# How Does Carlson Support Their Users? Ask David Farina

Here is the original question from David Farina on March 4, 2009:

Time of Concentration (TR-55)

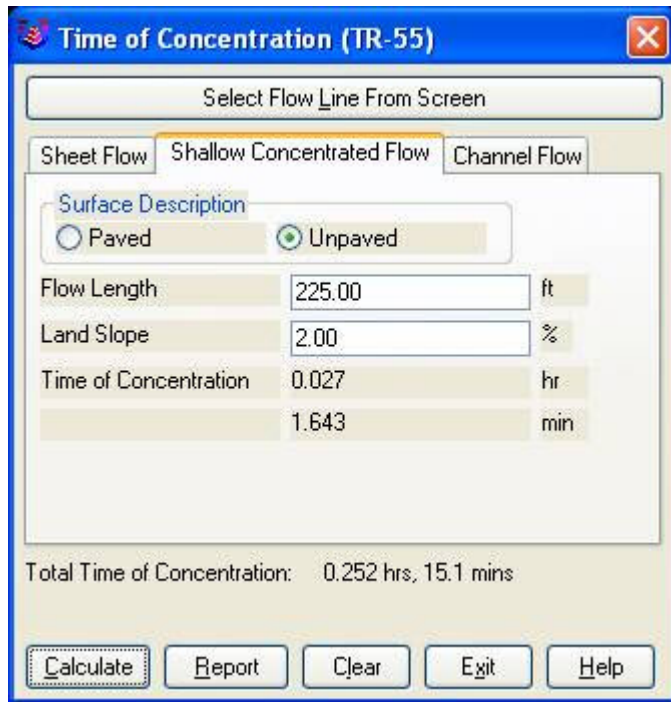
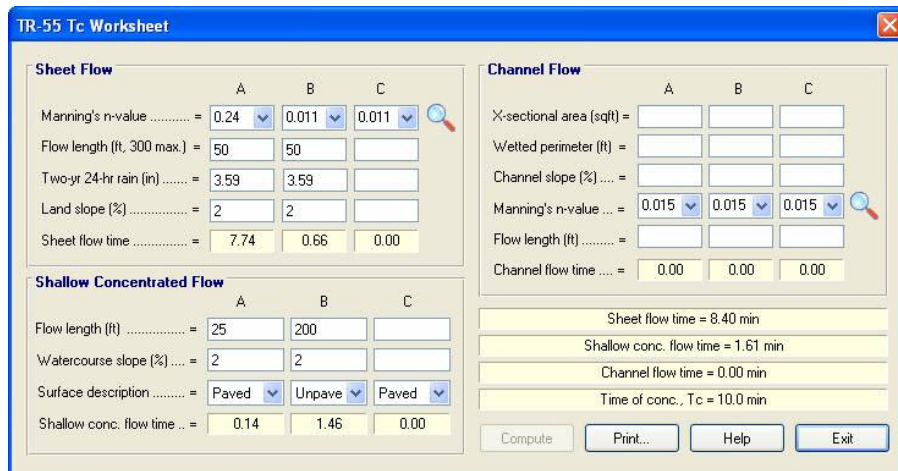
*I was going through a mock project to learn the hydrology part of Carlson and noticed a critical deficiency in Time of Concentration input. The review agencies around here want to see the TR-55 method. First, the TR 55 minimum sheet flow needs to be 100' instead of 300'. They recently changed it per the TR-55 Web site. Second, I don't think I've ever had a project where you didn't have to split one of these flow types*

into 2 or more manning's roughness areas.

For example: a flow path that starts on dense grass for 50' then passes over asphalt for 75' and back to grass for 200' would need to be calculated as follows:

Sheet flow 50' Grass -> Sheet flow 50' Asphalt -> Shallow Concentrated flow 25' Paved -> Shallow Concentrated flow 200' UnPaved.

But as you can see the Carlson input only allows for one entry per flow type.

*Below is the Intellisolve version: Notice the A, B C*

*There is a 5.1 minute difference in TC results which results in a 2 CFS difference in the 100yr example below:*

*Here's an update to the Tc by TR-55 routine that allows unlimited number of breakouts. This update is for Carlson 2009 on Acad 2007-09. To install, unzip and copy the arx to the Carlson2009LSP folder. Let me know if you need a different version or have more suggestions.*

**Time of Concentration (SCS)**

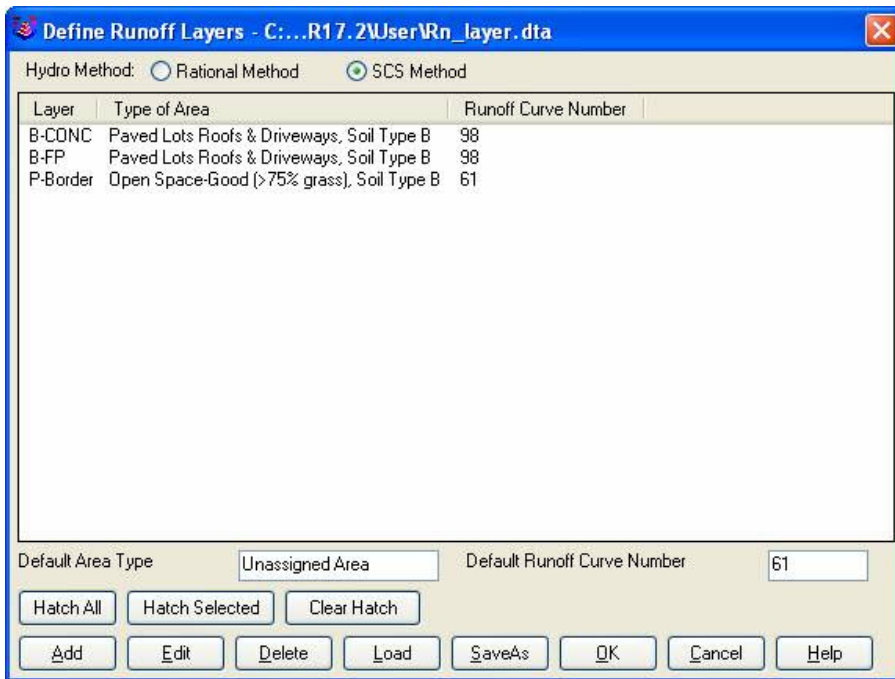
*If the above example is that different then I am also concerned about how the Time to inlet is calculated in the example below:*

*Was the SCS method used to get the 7.1 min value?*

*Notice the 7.5 value in the TC dialog to the right.*

*This was the value if I SELECT FLOW LINE FROM SCREEN and pick the path that the dialog on the left generates.*

*Can I generate a report of how the time to inlet was*

*calculated?*

*Maybe there can be a button next to the Time to inlet to select TR-55*

*Maybe Mannings coefficients can also be put into the WATERSHED->DEFINE RUNOFF LAYERS to be used for this calc as the flow path passes through each polyline area the same way Carlson already calculates the composite CN.*

*For the Storm Sewer Network routine, I put it on the to-do list to add a Select button next to the Tc to show the components that make up the Tc like the Select button does for CN. Also we will look at adding Manning's n to the Define Runoff Layers for use with Tc calcs.*
